TECHNICAL NOTE

Reference: P0421t04v02

Revised Response to Submissions Ivanhoe Estate, Macquarie Park (SSD 8707)

Figure 1: 2021 Traffic Volumes

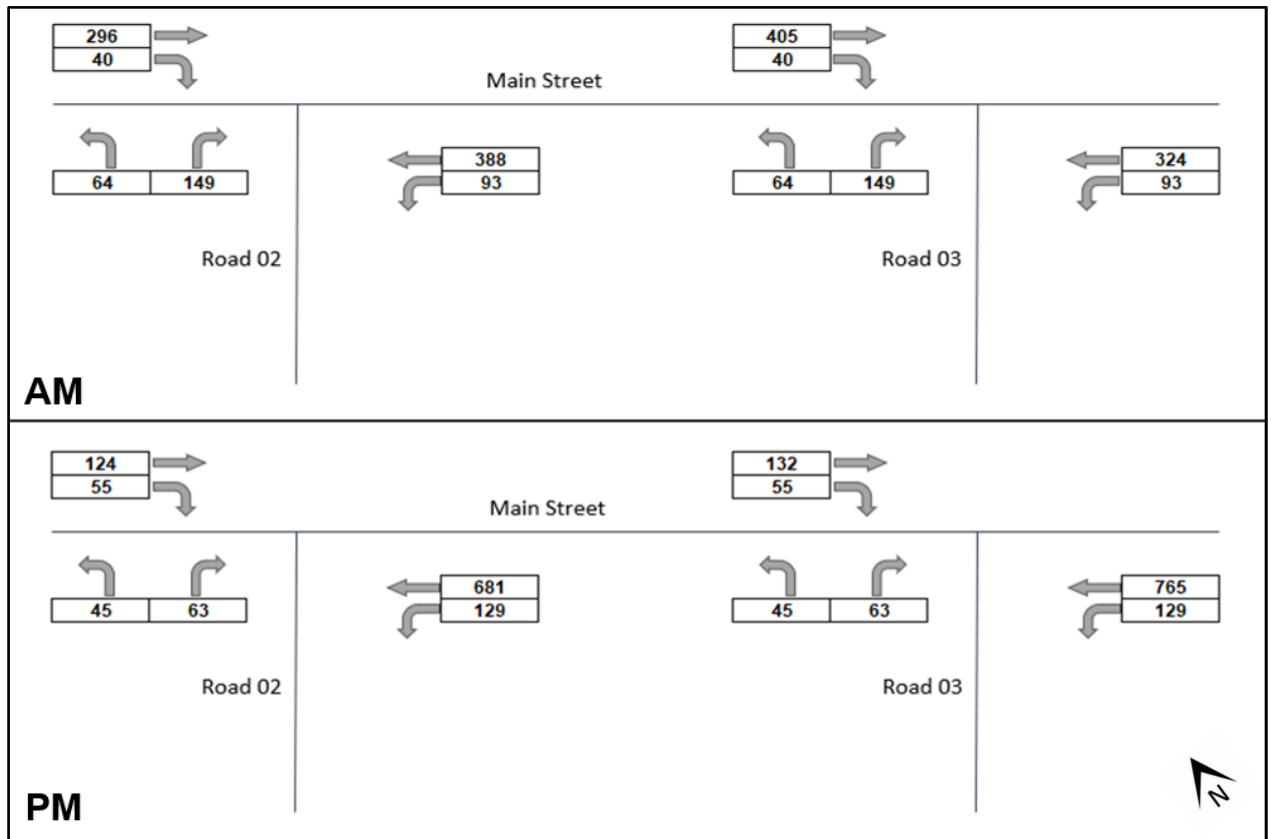
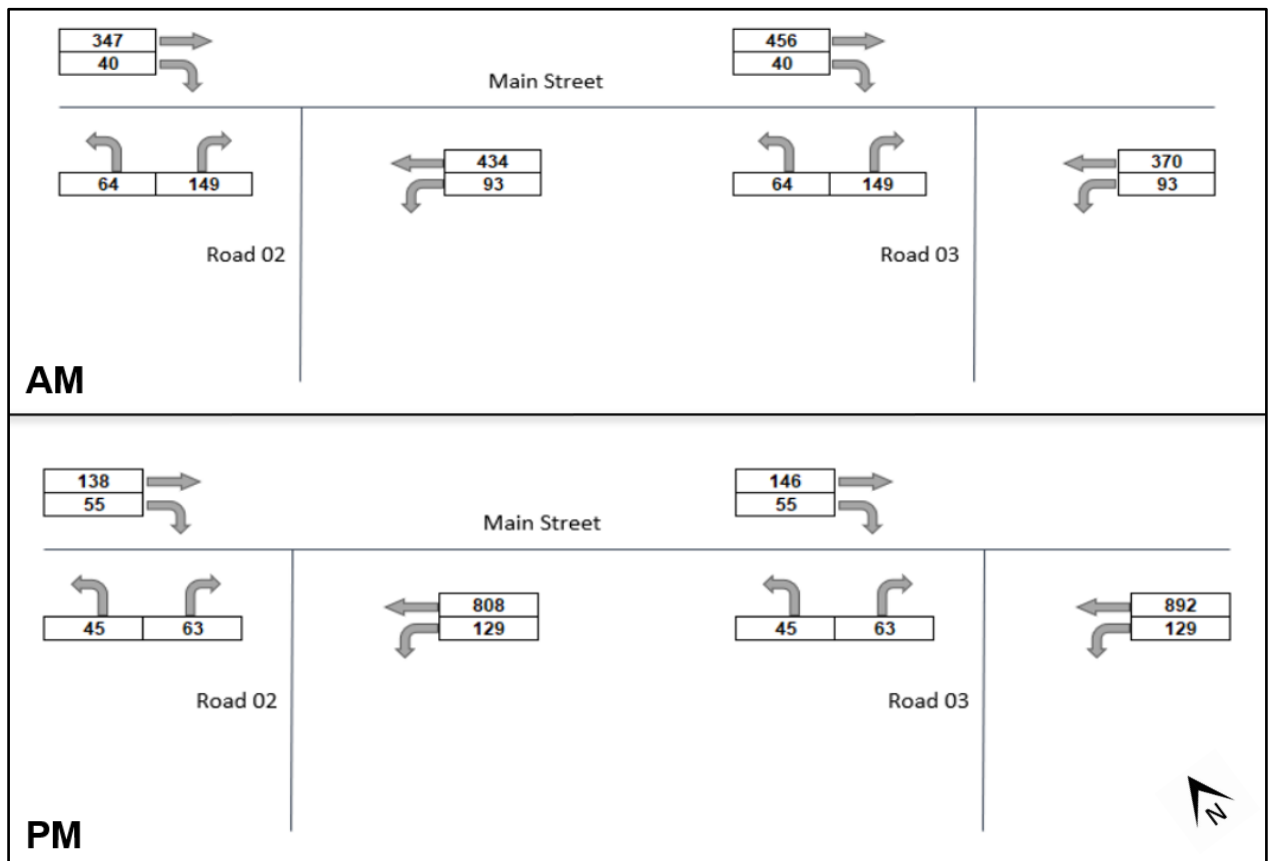
Council seeks that a condition be imposed requiring the applicant/developer to construct a roundabout at the intersection of Road No. 1 / Road No. 2 and Road No. 1 / Road No. 3. This must be incorporated as part of the appropriate stages of construction. Suitably prepared civil plans shall be submitted to and approved by City of Ryde prior to the determination of any detailed application relevant to the particular stage.

Ason Group has request information from Council in regard to the justification for these roundabouts, but no information has been made available by Council as to their purpose. Notwithstanding, SIDRA analysis has been undertaken to examine the future operation of these intersections using the traffic volumes extracted from the Aimsun model. These volumes are shown in **Figure 1** and **Figure 2** below, noting that Road No. 1 is referred to as Main Street in these Aimsun outputs.

These SIDRA results demonstrate that both the Main Street intersections will operate with very good levels of service under the future development scenarios (for both the 2021 and 2031 horizon years). As such, it is the conclusion of Ason Group that there is no reasonable justification for the provision of roundabouts at these intersections instead of the proposed priority control, particularly when [the provision of the roundabouts would results in the significant loss of social housing dwellings.

Figure 3: Main Street / Lyonpark Road SIDRA Intersection Layout

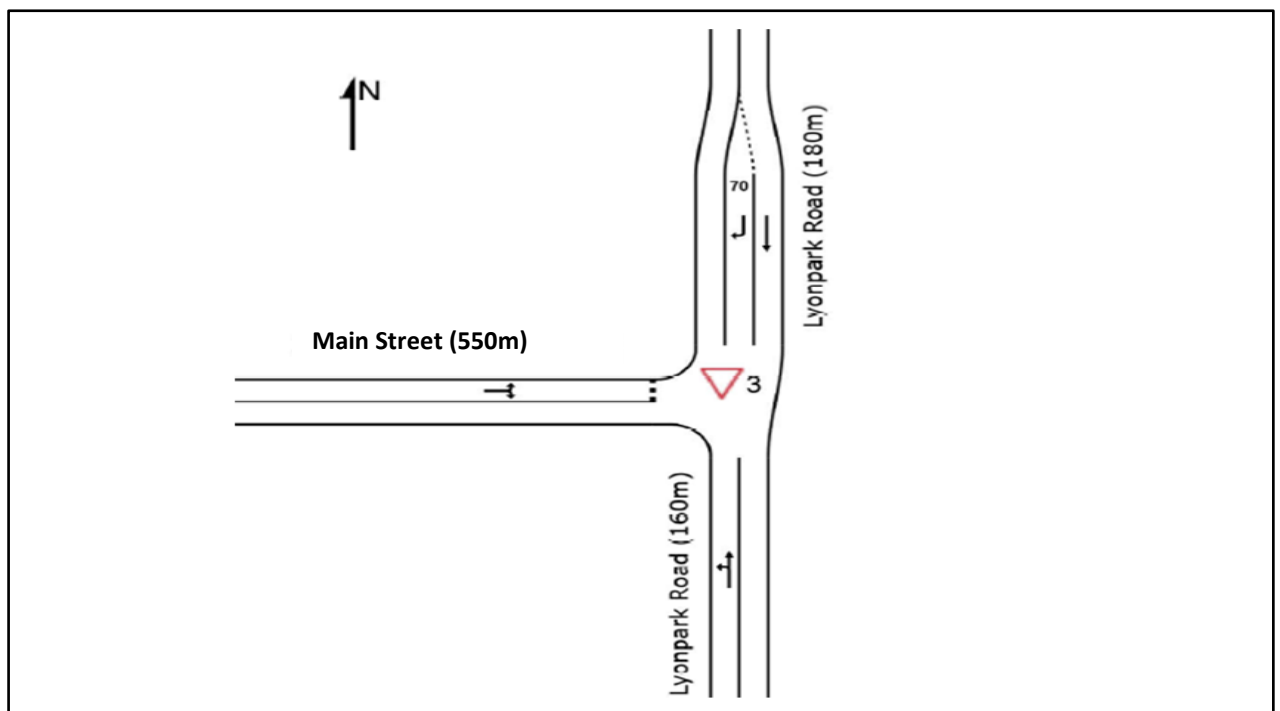
The applicant shall construct, as a minimum, a roundabout at the intersection of Road No. 1 and Lyonpark Road. Suitably prepared civil plans shall be submitted to and approved by City of Ryde prior to the release of any bonds associated with the civil infrastructure. Council seeks that the Concept Plan be amended to indicate this roundabout at the location and a condition be imposed requiring details to be submitted as part of any subsequent development application for approval by Council.

Notwithstanding, further intersection modelling has been undertaken to assess the capacity of the Main Street / Lyonpark Road intersection during the AM and PM peak periods for the 2021 scenario. The existing priority controlled intersection performed acceptably in the 2021 scenario; however, the preferred layout option shown in **Figure 3** below also incorporates a 70m dedicated right turn bay into Main Street, and has a separate southbound through lane.

The results shown in **Table 4** below demonstrate that the intersection continues to operate with a good level of service further to the Proposal.
